Appl. No. 10/648,900  
Amendment dated March 18, 2004  
Reply to Office Action of March 4, 2004

**REMARKS/ARGUMENTS**

This Amendment is responsive to the Office Action mailed March 4, 2004.

Fig. 2

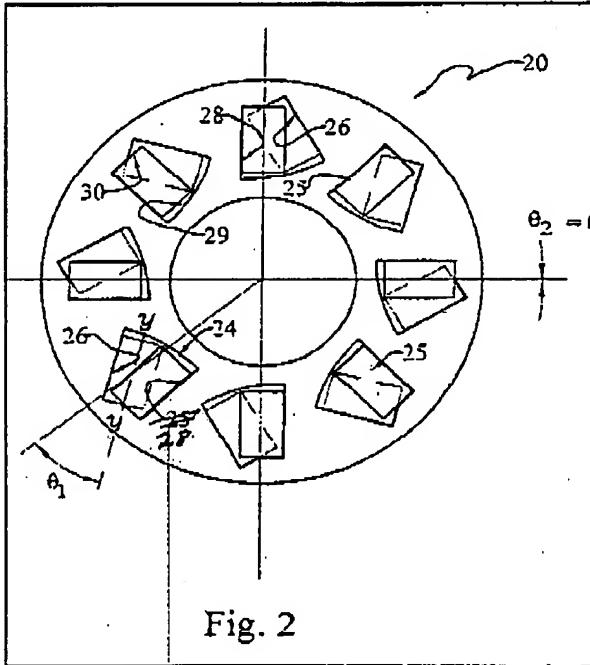
Moreover, Applicant proposes to amend Fig. 2 to change reference numeral "25" to -- 28 --, as shown in the insert. This merely makes the drawing consistent with the specification.
